## SERVICE BULLETIN

**APPLICABILITY:** 2015-16MY Legacy and Outback  
2012-16MY Impreza  
2013-19MY Crosstrek  
2013-19MY Forester  
2015-16MY WRX and STI

**NUMBER:** 12-203-16R

**SUBJECT:** Squeaking Sound from Front Seat Buckle

**OLD** Wave Washer

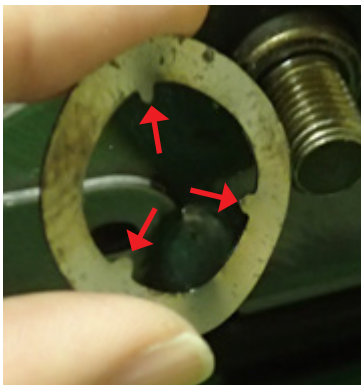
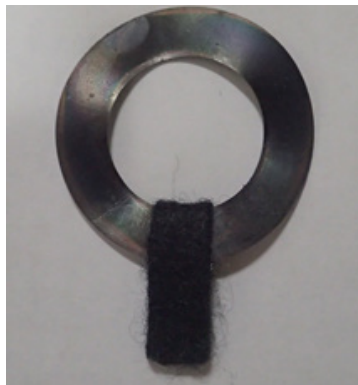
This bulletin provides a procedure to address customer concerns of a squeaking sound originating from where the front seat belt buckle assembly attaches to the seat frame. A design change was made to the wave washer used at the attachment point to eliminate the sound. The sound can be heard when moving the buckle assembly side to side.

The 3 “tang” seen on the inside of the **OLD** wave washer have been deleted. The inside diameter of the **NEW Spring** wave washer has been decreased and a small felt added to allow the washer to turn smoother with the buckle and have a better fit on the shoulder portion of the retaining bolt.

The part number for the new wave washer is **64168FL000**.

**NEW Spring** Wave Washer

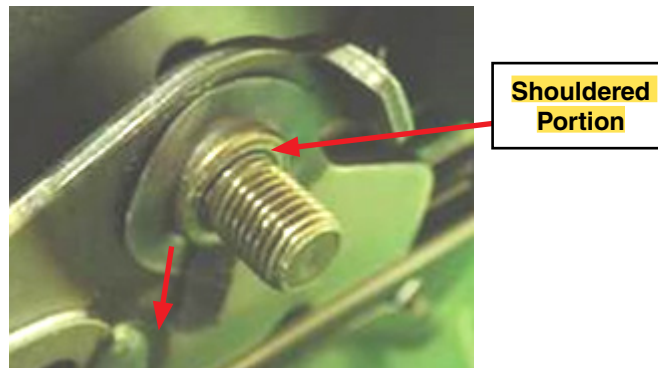
- Install the new **spring** wave washer onto the groove in the **shouldered portion** of the mounting bolt as shown below. The felt **portion** should be at about the 6:00 position (pointing down).

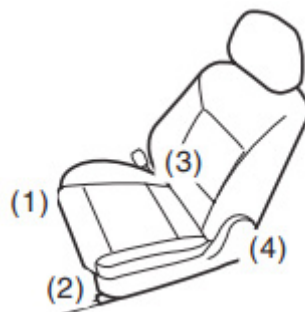
- **IMPORTANT: CAREFULLY** reinstall the seat belt buckle assembly onto the shouldered portion against the wave washer and hold it **firmly** in place while tightening the retaining nut.
- Torque the retaining nut to 38 Nm (28 ft. lbs.) and confirm the seat belt buckle assembly moves freely. **If the buckle assembly feels like it is binding, make sure the spring wave washer and / or buckle assembly did not come off the shouldered portion of the mounting bolt while the retaining nut was being tightened. If the spring wave washer came off, it most likely was pinched and damaged, requiring replacement. DO NOT try to straighten / reuse it.**
- **Reinstall the seat assembly in reverse order of removal.**
- **IMPORTANT:** Torque the four (4) seat assembly retaining bolts to 53 Nm (39 ft. lbs.) using the sequence shown in the illustration below.
